GE Hitachi Nuclear Energy

MFN 08-618

**Subject: Response to Portion of NRC Request for Additional Information
Letter Nos. 152 and 168 Related to the ESBWR Design
Certification – Licensing Topical Reports (LTR) NEDO-33337
“Initial Core Transient Analysis” and NEDO-33338 “ESBWR
Feedwater Temperature Operating Domain Transient and
Accident Analysis” – RAI Numbers 15.2-14, 15.2-17, 15.2-19,
15.2-21, 15.2-25, 15.2-26, 15.2-31, 15.2-32, 15.2-35 and 15.2-37**

LTRs NEDO-33337 and NEDO-33338 Markups

Figure 2.3-1a. Loss of Feedwater Heating

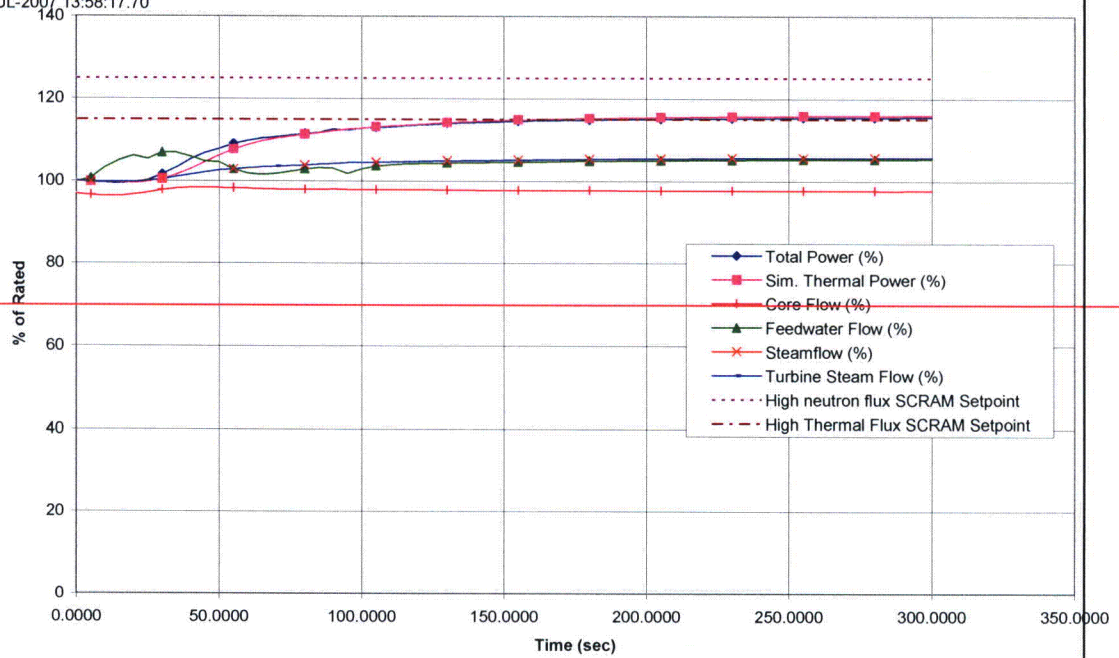
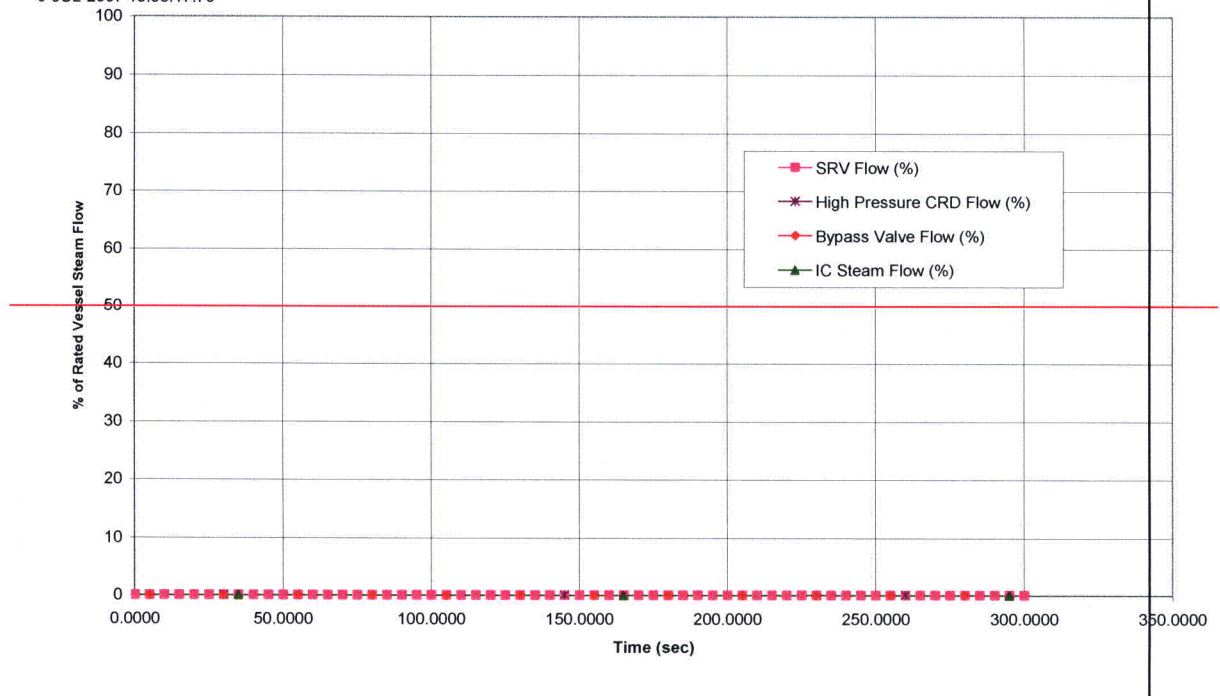
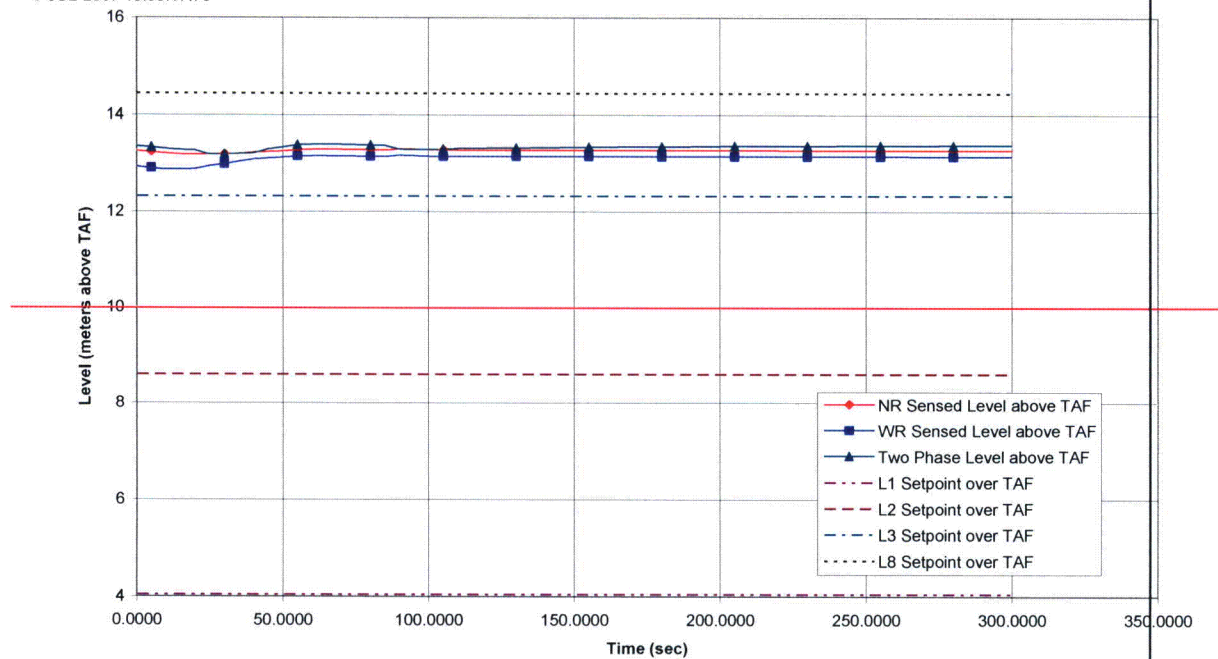
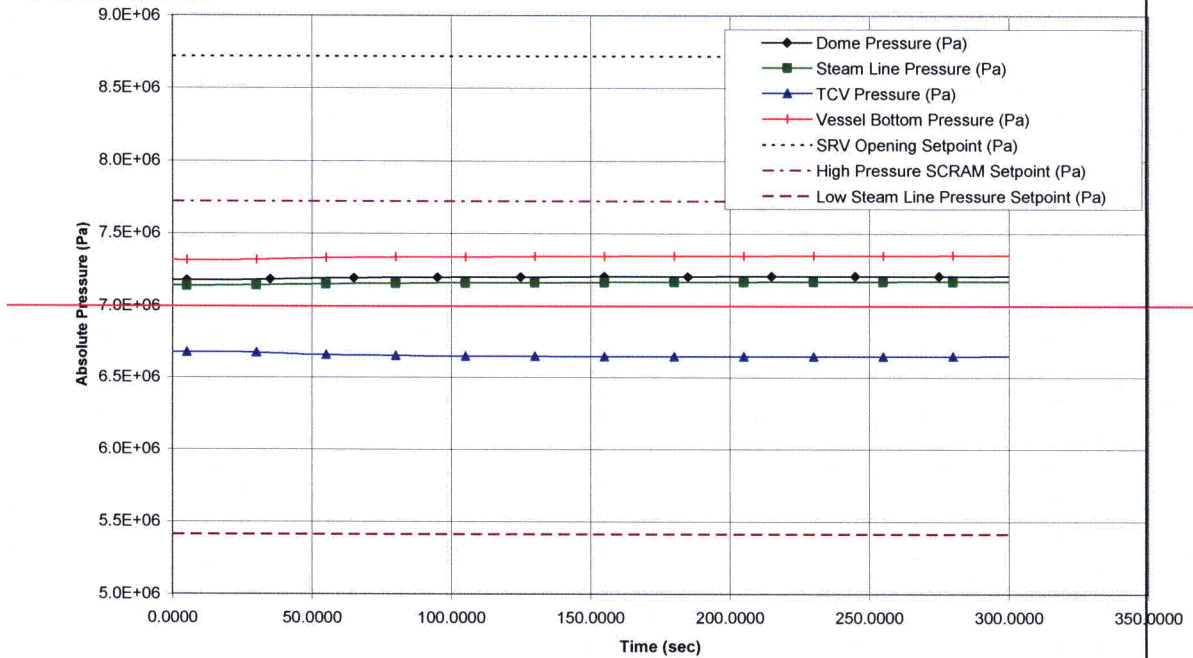
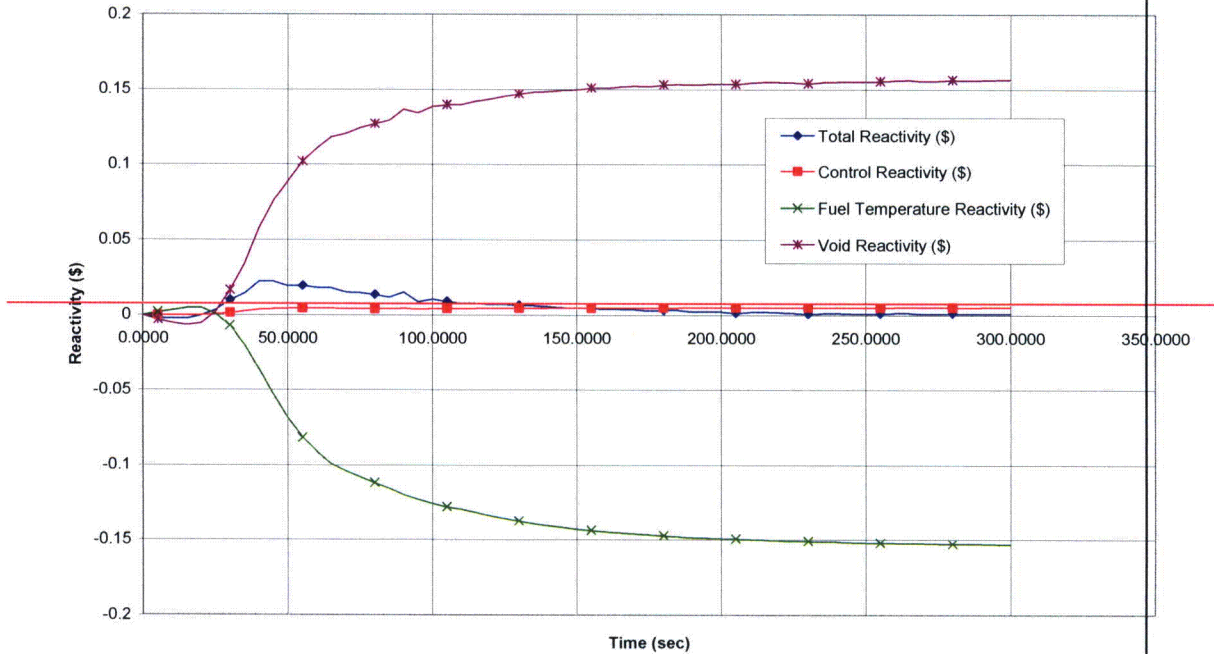
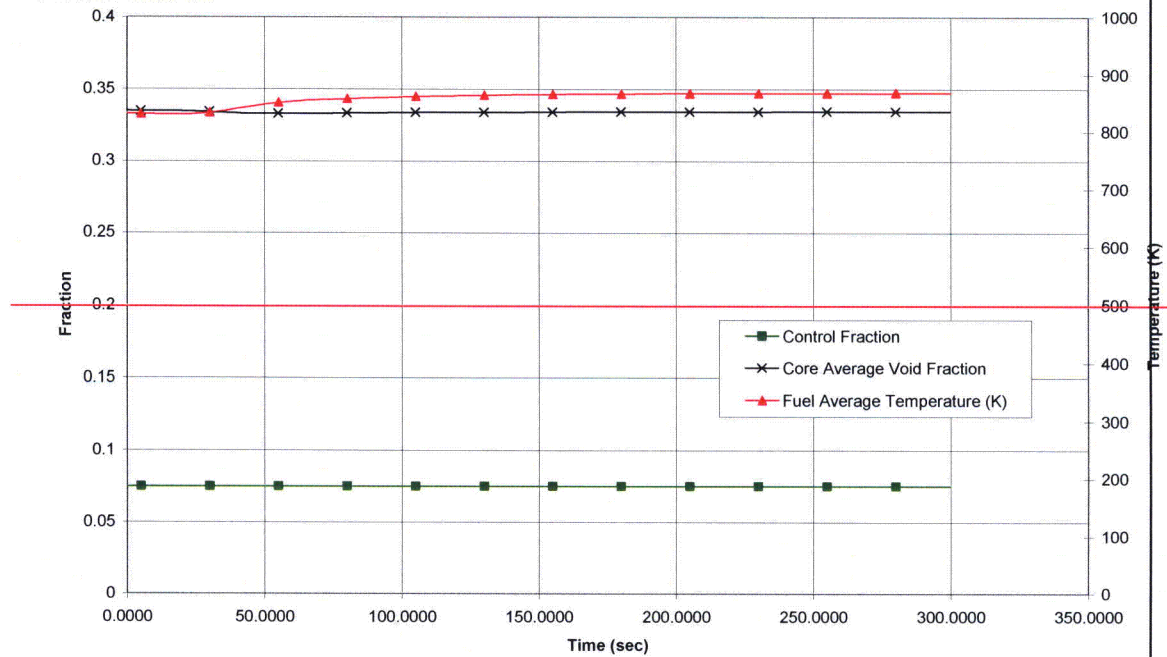
NEDO-33337, Section 2.3.1.1.1 states: "Under circumstances in which no SCRR/SRI pattern is defined, the power would rise to the simulated thermal power trip scram setpoint." This implies that there is no credit taken for SCRR for the initial core analysis. What is the difference between this event and Loss of Feedwater Heating without SCRR?

NEDO-33337, Section 2.3.1.1.1 states that no single operator error or equipment failure shall cause a loss of more than 55.6 °C (100 °F) FW heating. However, Table 2.3-5 shows the analysis assumes a change of 39 °C (70 °F). Why is 70 °F assumed instead of 100 °F?

The Loss of Feedwater Heating (LOFWH) event in the LTR will be updated to match the same event found in Chapter 15.2 of DCD Tier 2, Revision 5. The attached markup also reflects changes from DCD Revision 5. This analysis uses Select Rod Insertion (SRI) rods but no Selected Control Rod Run-In (SCRR) rods. SRI rods perform a similar function to SCRR rods, to reduce the core power and limit the change to Minimum Critical Power Ratio (MCPR). SRI rods are used when the slower moving SCRR rods would not adequately affect the top peaked power profile. SCRR rods may be added to reduce power further (as needed), but are not required to demonstrate acceptable CPR performance.

A feedwater (FW) temperature reduction of 39°C (70°F) is assumed because it increases the power to the simulated thermal power trip setpoint (115%) without initiating the scram. Any additional FW temperature reduction results in a scram, and terminates the event. The LOFWH event in the LTR will be updated to match the event found in Chapter 15.2 of the DCD Tier 2, Revision 5, including credit for Selected Control Rod Run-In (SCRRI)/Select Rod Insertion (SRI) function and a FW temperature reduction of 55.6°C (100°F). The attached markup also reflects changes from DCD Revision 5.

Time (s)	Event
0	Initiate a 3955.6°C (70100°F) temperature reduction in the FW system.
<u>2322</u> (est)	RC&IS initiates Selected Rod Insertion plus Selected Control Rod Run-In (SCRRI/SRI). No rods are assigned for this exposure point.
25 (est.)	Initial effect of unheated FW starts to raise core power level.
≈150.0	The STPT setpoint (115%) is reached, the activation of Scram is not credited
<u>24</u>	<u>First SRI group inserts (one HCU, 2 control rods, fails to actuate) and SCRRI starts</u>
<u>34</u>	<u>Second SRI group inserts</u>
<u>44</u>	<u>Third SRI group inserts</u>
<u>54</u>	<u>Fourth SRI group inserts</u>
<u>57</u>	<u>Steam flow below 60% rated</u>
<u>64</u>	<u>Fifth SRI group inserts</u>
<u>74</u>	<u>Sixth SRI group inserts</u>
<u>82</u>	<u>Power below 60% rated</u>
300 (est.)	Reactor variables settle into new steady state.
